SCOTTISH HOSPITALS INQUIRY

Bundle of documents for Oral hearings commencing from 19 August 2024 in relation to the Queen Elizabeth University Hospital and the Royal Hospital for Children, Glasgow

Bundle 21 - Volume 5

Responses to Expert Reports of Andrew Poptlett and Allan Bennett

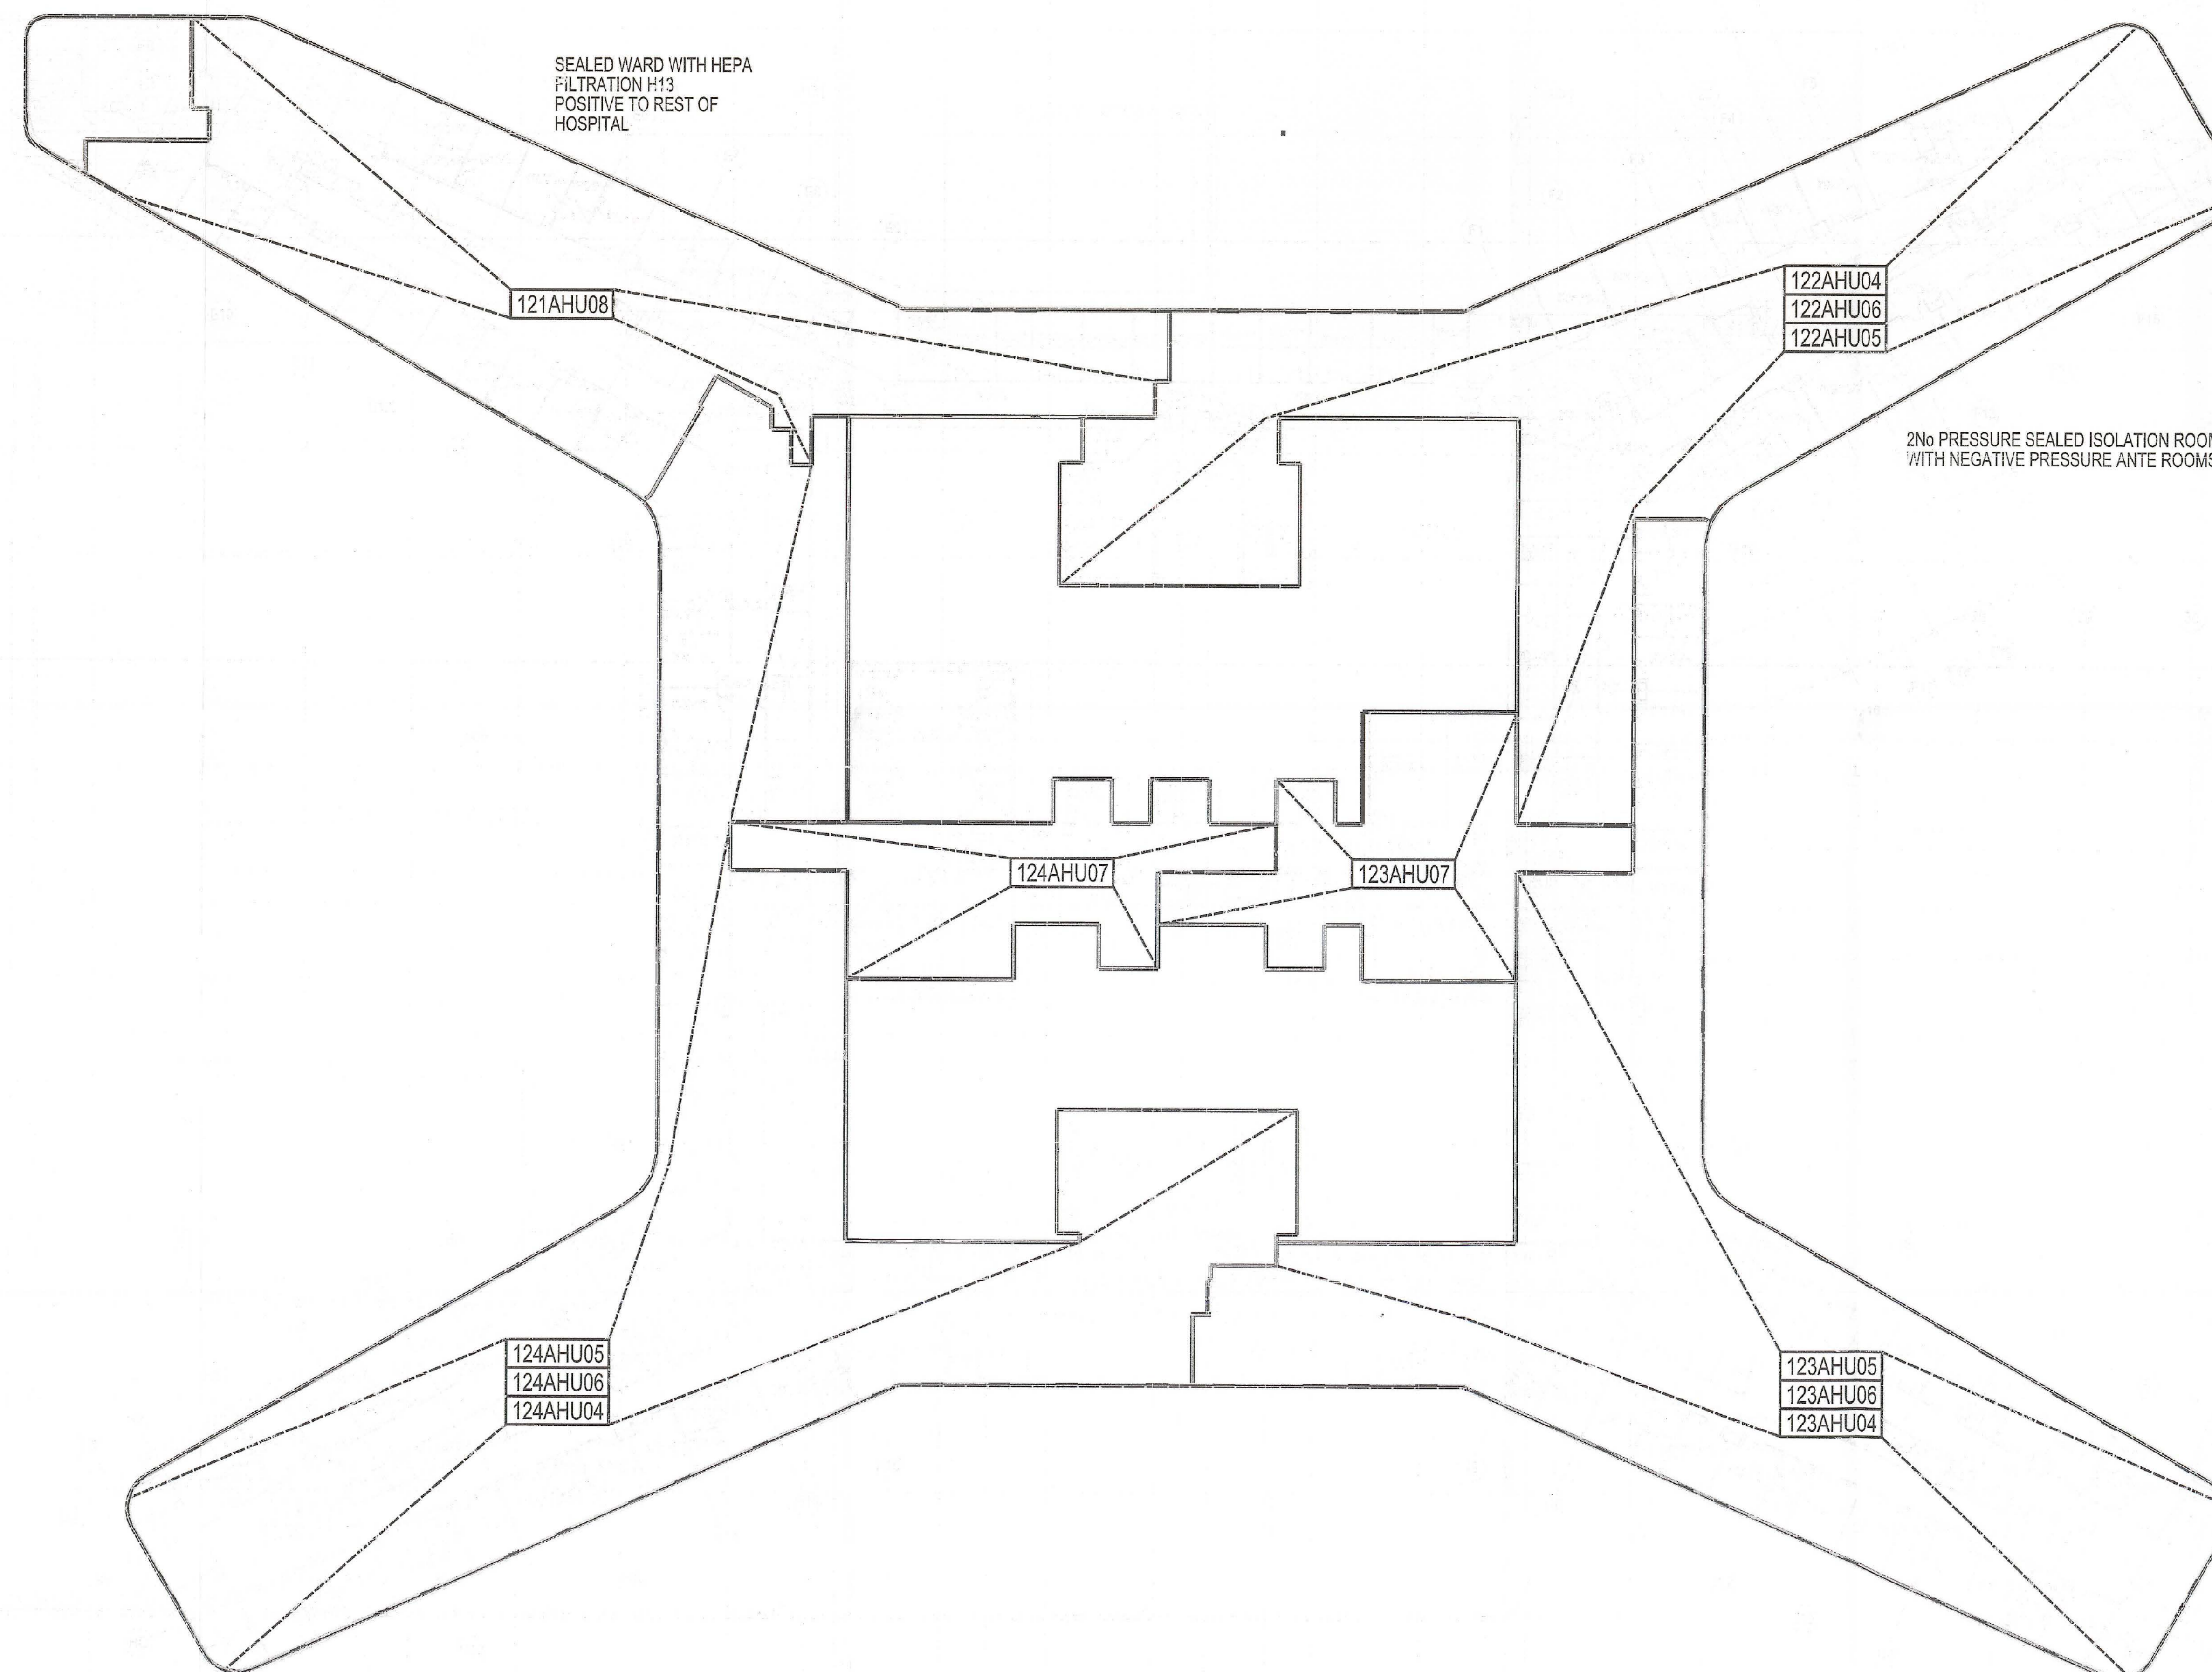
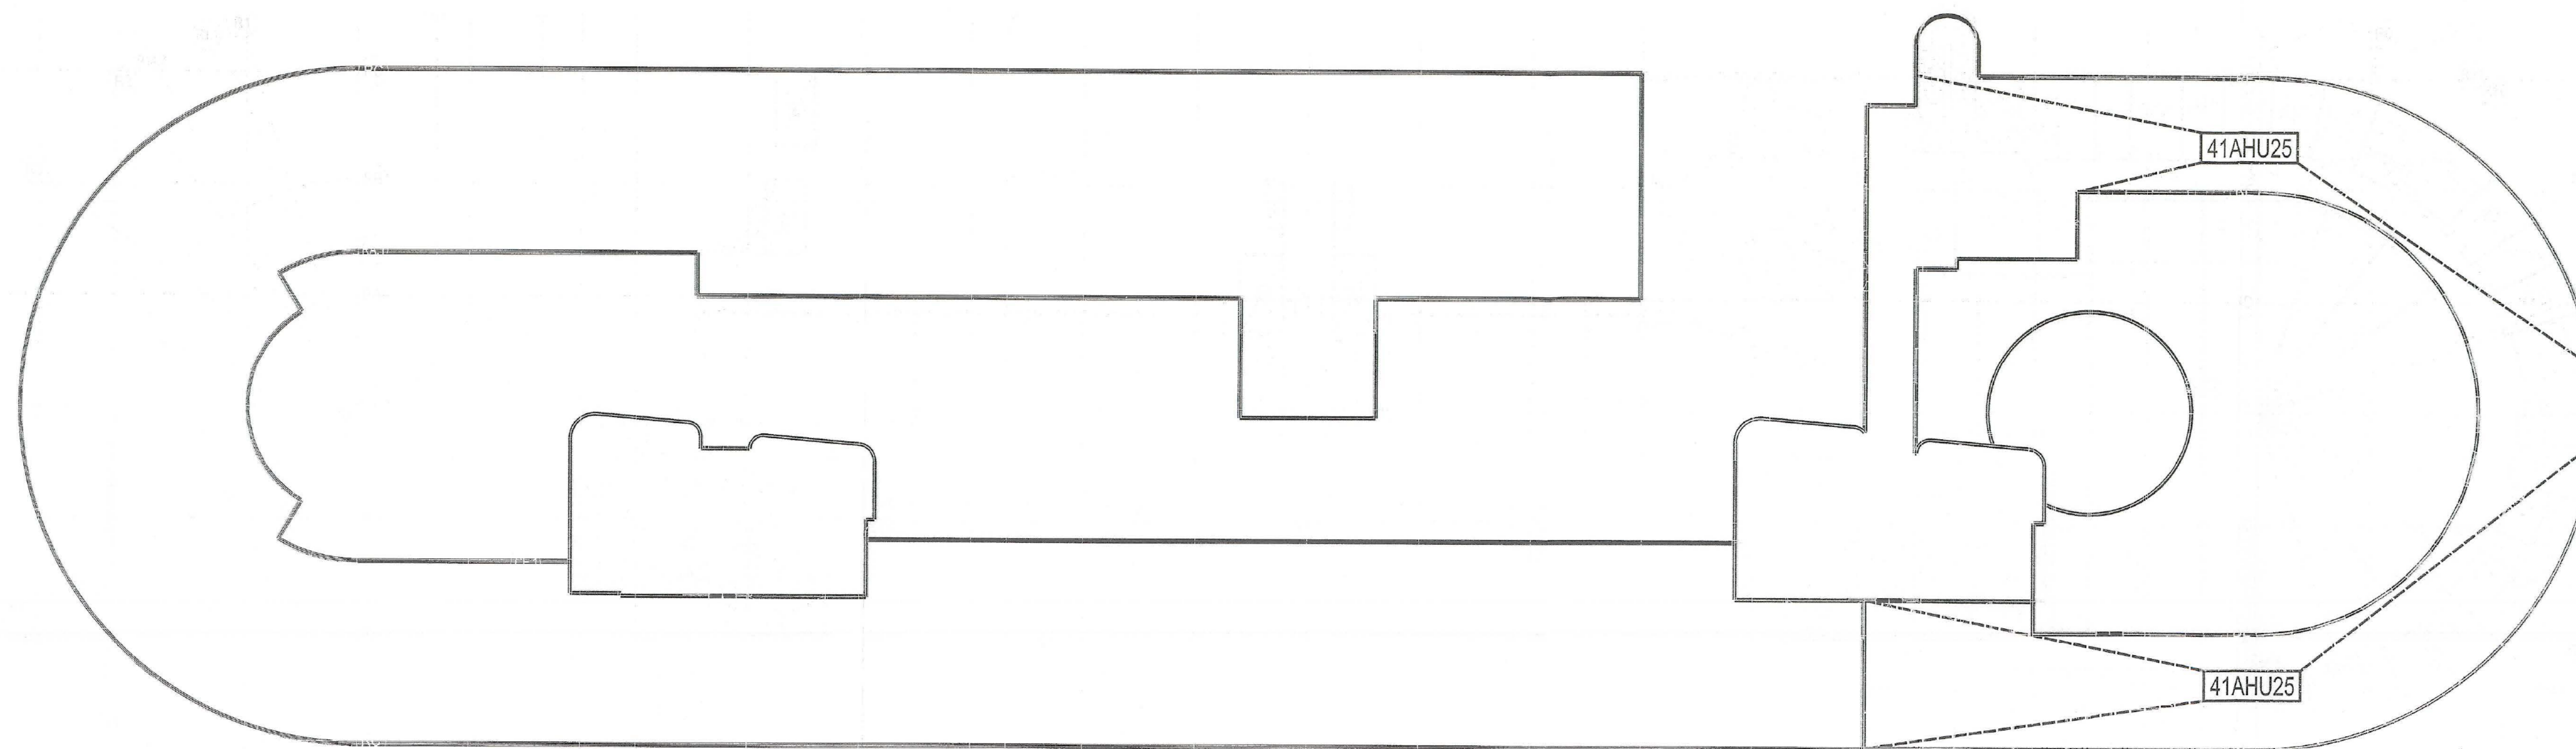
Paragraph 10.13: *“The requirement for dew point control of CBUs has been specified in guidance since 2007 as has the need for regular maintenance/cleaning and access for maintenance/cleaning. However, dew point controls were not installed leading to widespread condensation events in the QEUH.”*

9. The Employer’s Requirements, Volume 2/1, Appendix M&E3, Paragraph 2.43 required that the control settings of chilled beam units must ensure that the external elements of the beam are always above dew point. Currie & Brown is not aware of whether that requirement was complied with.
